SEWAGE DISPOSAL SYSTEM

SUBDIVISION Chessie Crossing LOT 3 ROAD 713 Chessie Crossing Way

PROPOSAL: BP application for pool and deck (BO0115842)

RE: Building Permit Application #B00115840
Proposed above ground pool and deck
713 Chessie Crossing Way

LOCATION DIAGRAM

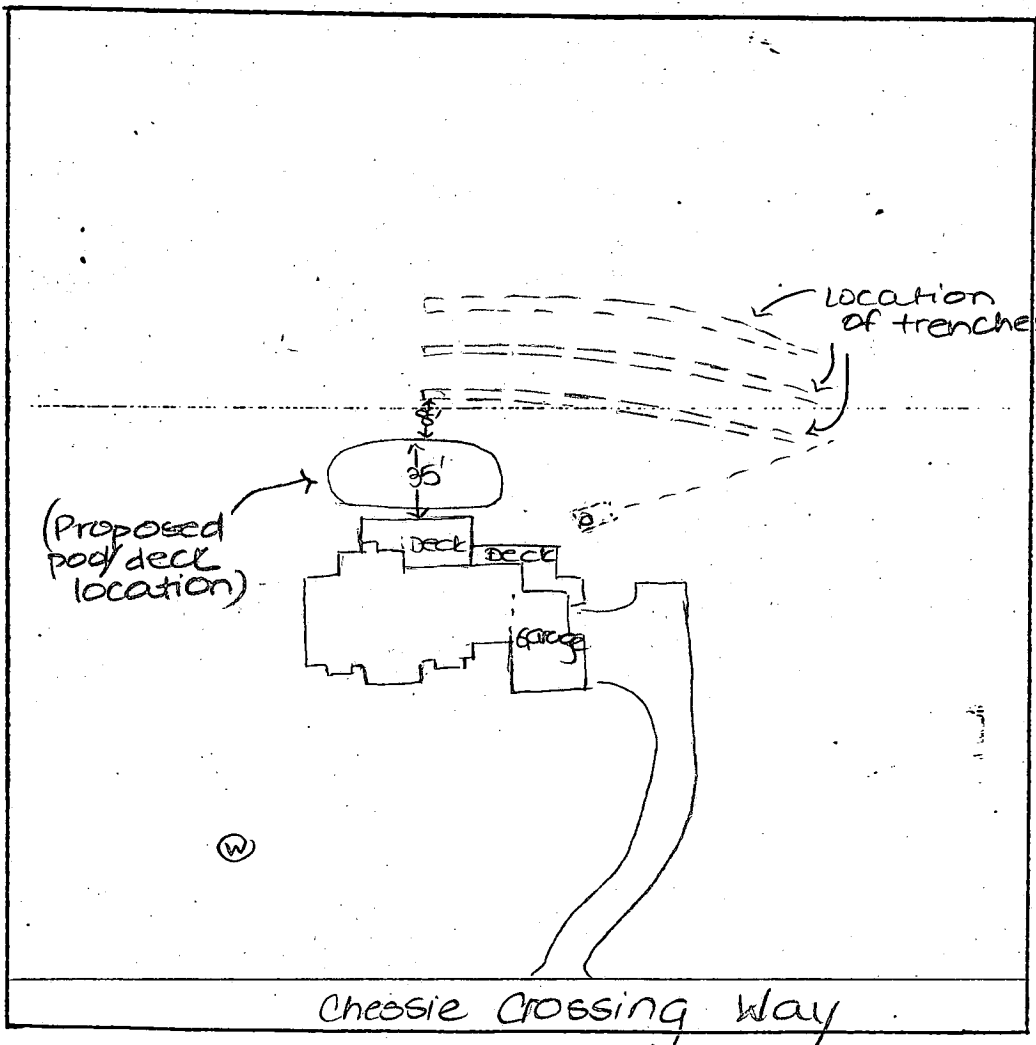
COMMENTS: Pool contractor outlined proposed location of pool/deck and location of trenches - proposed location not acceptable as shown (existing trench ~8 feet from edge as indicated) Advised owner and pool contractor of same.

SITE PLAN 1" = 50' 01"
 LOT 3 CHESSIE CROSSING
 HOWARD COUNTY, MARYLAND
 YOUNKIN RESIDENCE

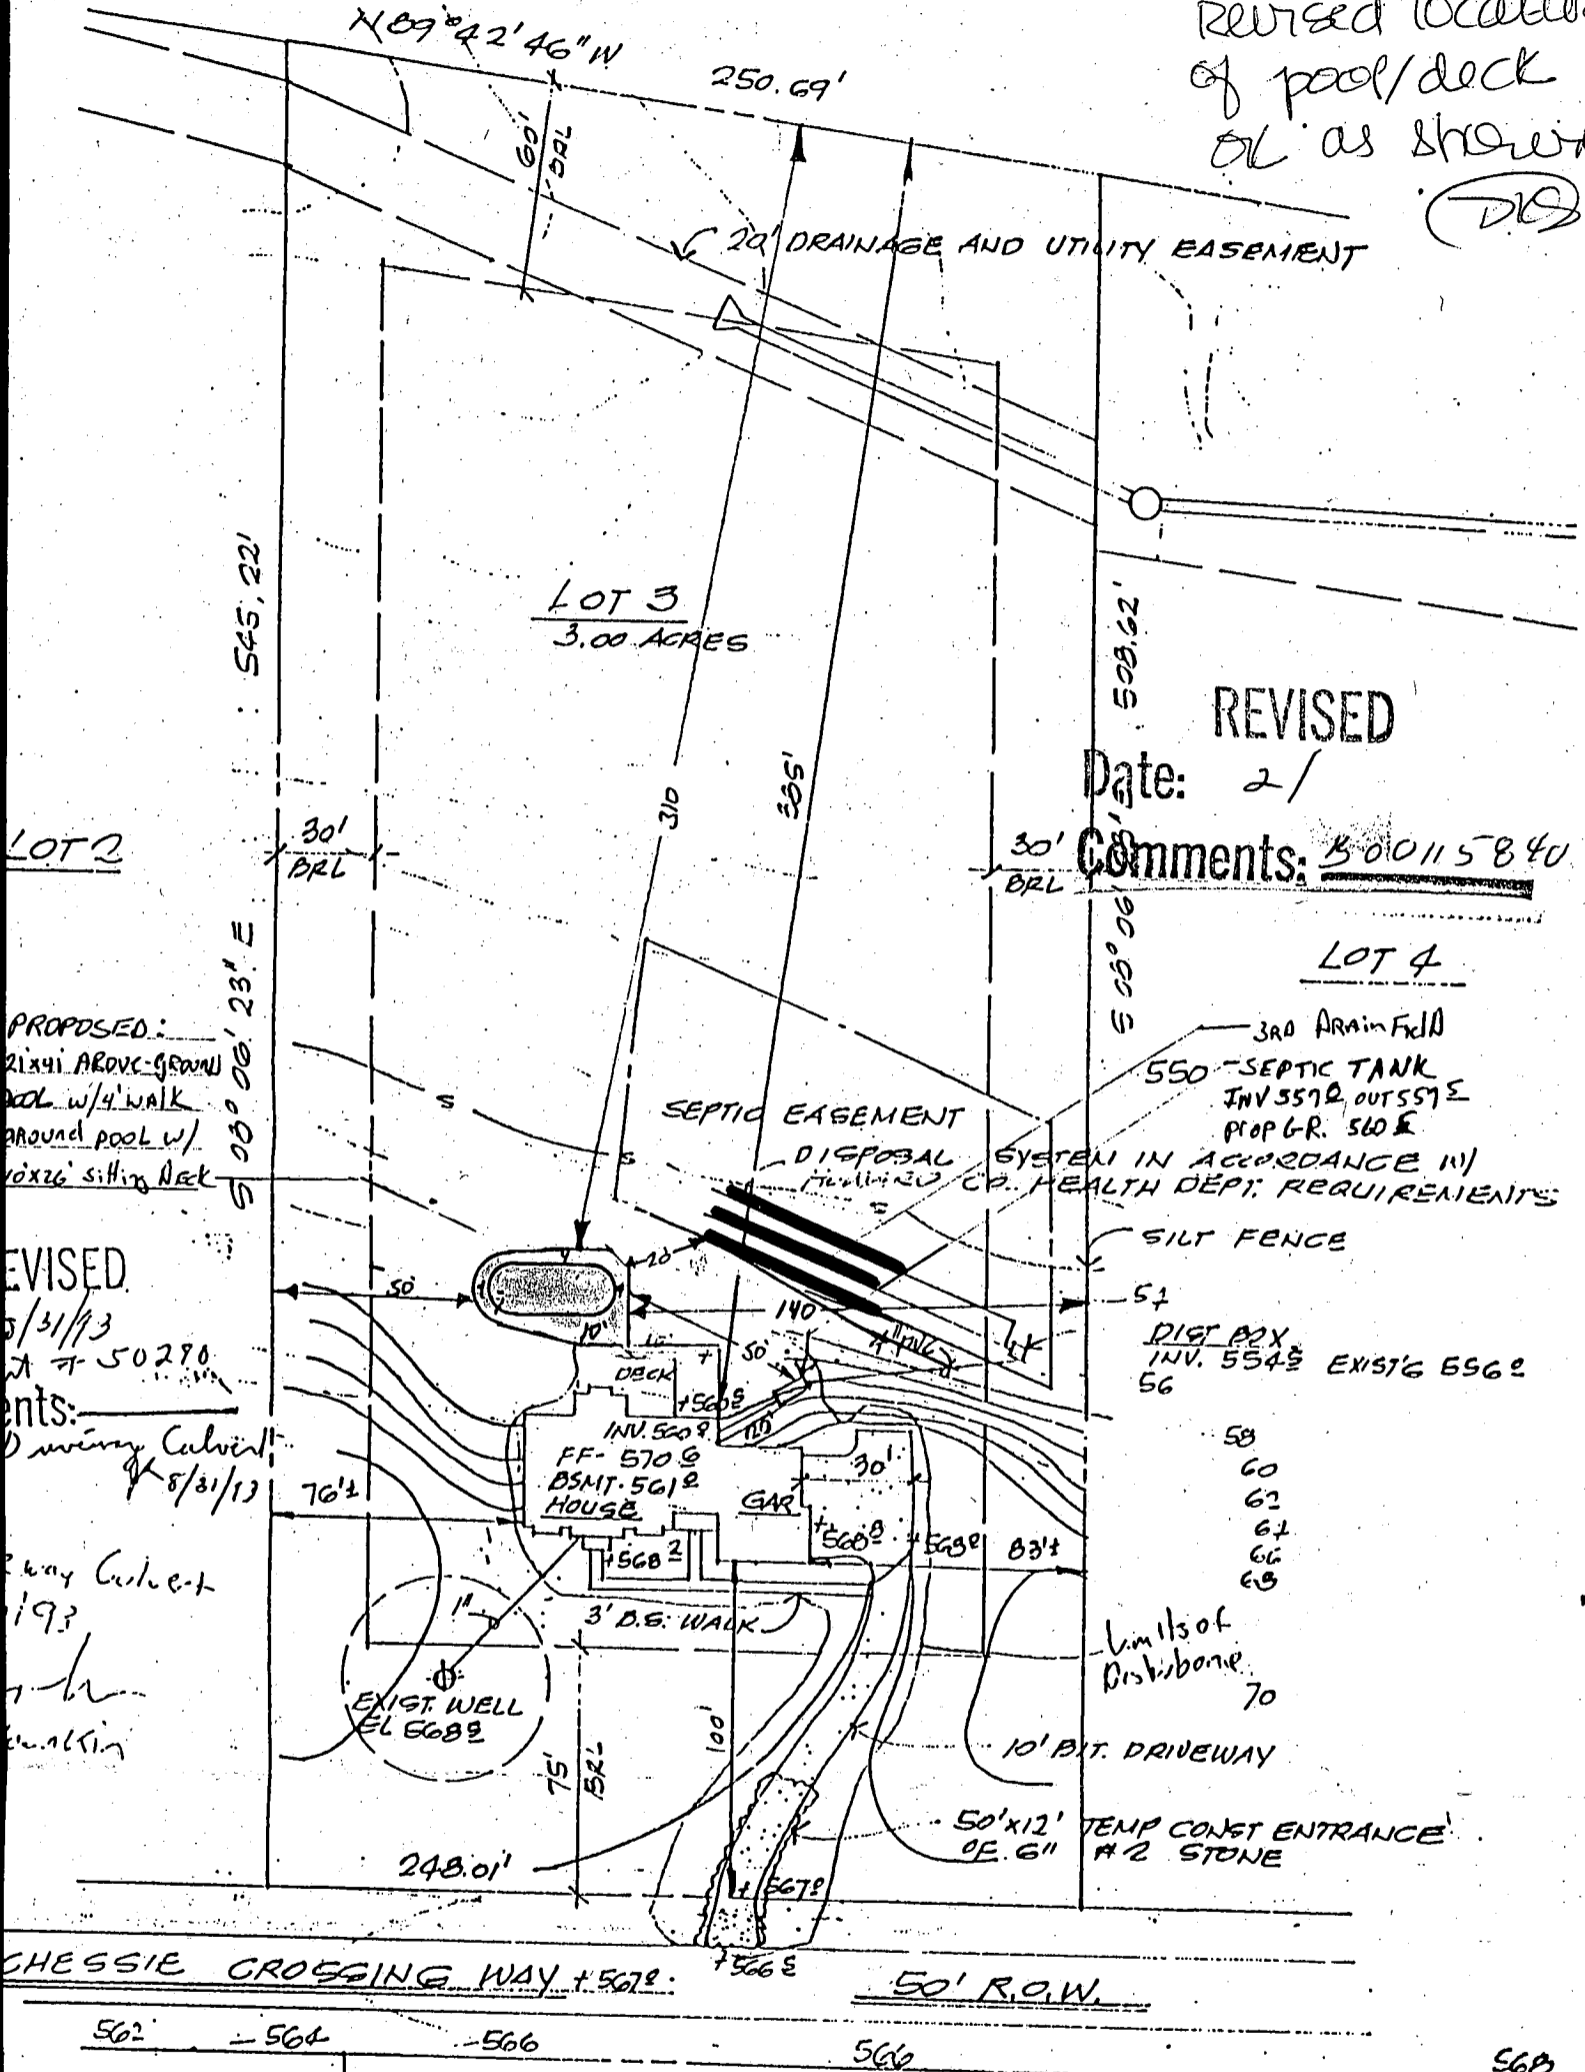
2/16/99
 Revised location
 of pool/deck
 as shown
 (DLS)

PROPOSED:
 21x41 ABOVE-GROUND
 POOL w/4' WALK
 AROUND POOL w/
 10'x26' sitting Deck
